# DICK'S SPORTING GOODS HOUSE OF SPORT JSP24-31

# PLAN REVIEW CENTER REPORT Planning Review

Dick's Sporting Goods JSP24-31 March 14, 2025

Revised Preliminary Site Plan and Special Land Use

DRAWING NO.

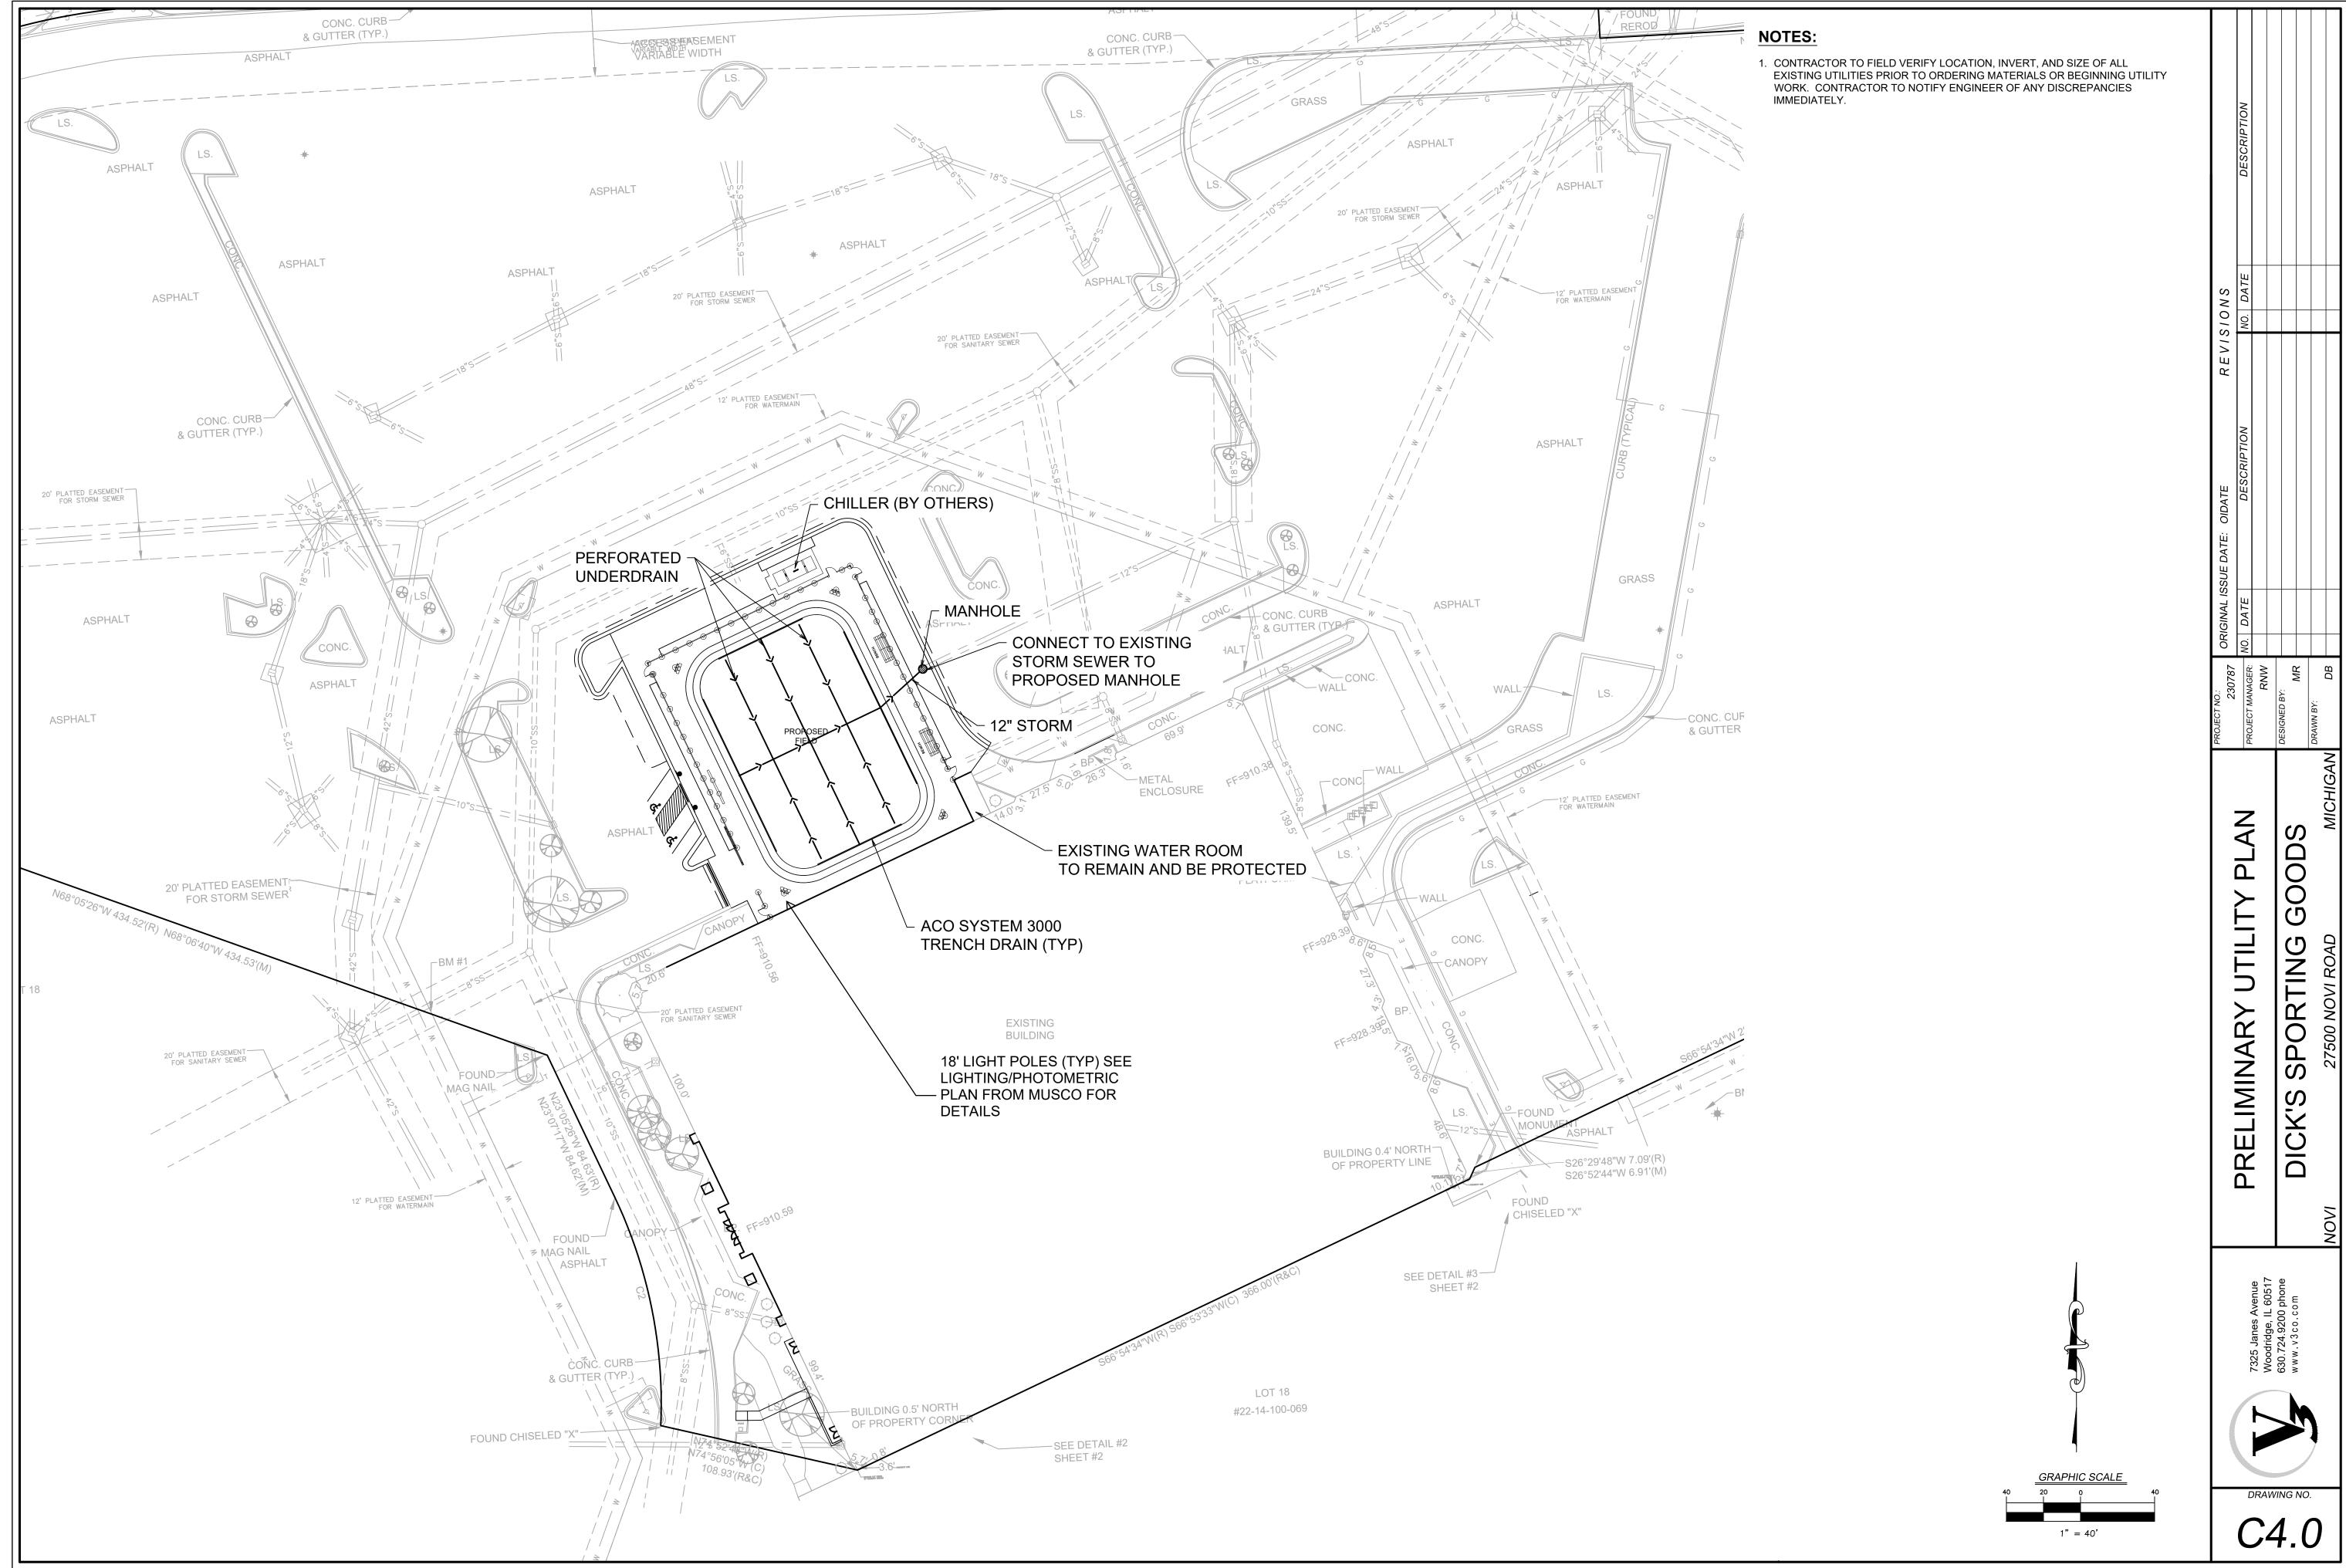
Comment 15: Sheet C4.0 indicates 18' light poles, lighting specifications and response letter indicate

Response:
